Recall Campaign

NHTSA#: 15V-877
 TC#: 2016-017

Date of Publication: February 2016

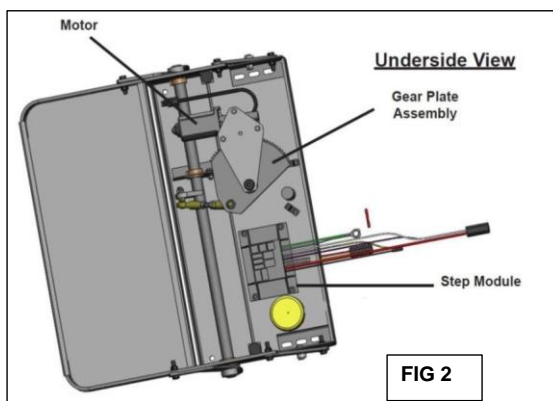
- Fig 1:** Open the complete step assembly and look at the bottom step, right corner for the label identifying the step as a **COACHSTEP**.
Fig 2: If the label is missing, look at the motor parts under the step.
 The **COACHSTEP** will have the motor, gear plate assembly and step module located as shown in this diagram.
- Complete the enclosed Reply Form and return to Jayco Engineering / Regulatory Compliance

| Action Required | Inspect current entrance step to determine if a LCI COACHSTEP. If a COACHSTEP is confirmed, the recall repair is required. Repair per LCI's recall Instructions provided. | | | |
